NUCLEAR SAFETY RELATED (U.S.)

REACTOR CONTAINMENT BUILDING PLAN AT EL. 786'-0" EOPY FOR PENETRATION 300 37

DWG NO. NS 1086

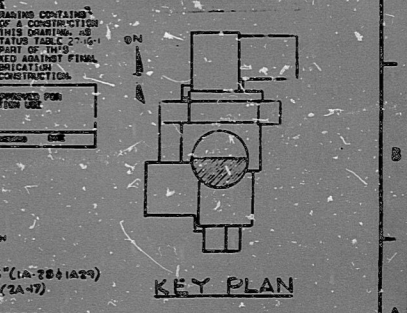
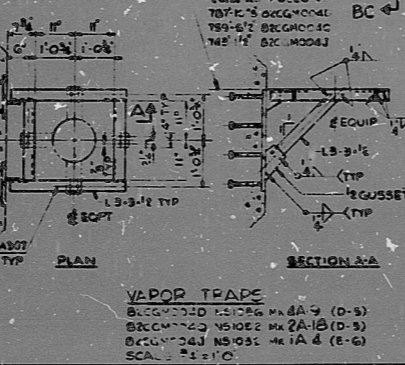
NO.	REVISION	DATE	BY	CHKD.	APP'D.	REVISION	DATE	BY	CHKD.	APP'D.	REVISION	DATE	BY	CHKD.	APP'D.	REVISION	DATE	BY	CHKD.	APP'D.	
1	FOR PREVIOUS REVISIONS SEE RECORD MAP																				
2	REVISED DETAIL NO. (HANDRAIL POST ARRANGEMENT, RAILING TYPE & SYMBOL (E-2) CINDT SM-100-105																				
3	ADDED DETAIL FOR EQUIPMENT MK 4A-21 (D-5) & MK 4A-22 (E-6) CINDT 27CS-DD-122G																				
4	ADDED DETAIL FOR EQUIPMENT MK 4A-28 (E-5) CINDT 27CS-DD-122G																				
5	ADDED HOLD #66000246 TO MK 4A-28 (E-5) CINDT 27CS-DD-122G																				
6	DELETED PEN 23-13 (D-5) CINDT 27AA/JC-1222
